Modification Recommended Service Note

P9375B Keysight Streamline Vector Network Analyzer

Serial Numbers: From MY61100288 to MY61100353

Potential lifted front panel overlay

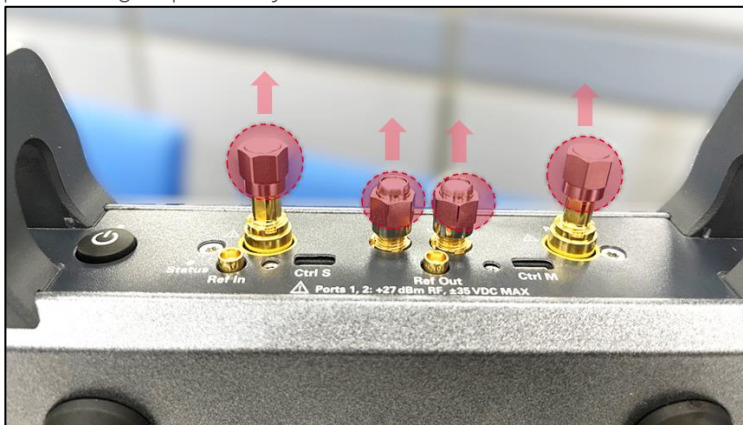
Keysight streamline series vector network analyzer (VNA) of serial number range identified in service note cover page might potentially exhibit the following lifted front panel overlay symptom.

Apart from cosmetic imperfections, the lifted front overlay could have led to non-fully attached *Ctrl S* micro-HDMI cable connector in multi-VNAs setup configuration.

-> Apply this service note only if end users' VNA is exhibiting the following symptom.

Procedure to replace the front panel overlay.

1. Remove the front handles. Detach the 50-ohm termination (LO-In, LO-Out, Port 1 & Port 2) or protecting caps if they are attached to the VNA.

2. Pry open the existing front panel overlay and remove it from front panel.
3. Clean the metal surface thoroughly and ensure it is free of adhesive residue.
4. Affix the new self-adhesive front panel overlay onto the metal surface.
5. Reinstall (reuse) the 50-ohm terminations and port protecting caps accordingly.

6. Reinstall (reuse) the front handles.
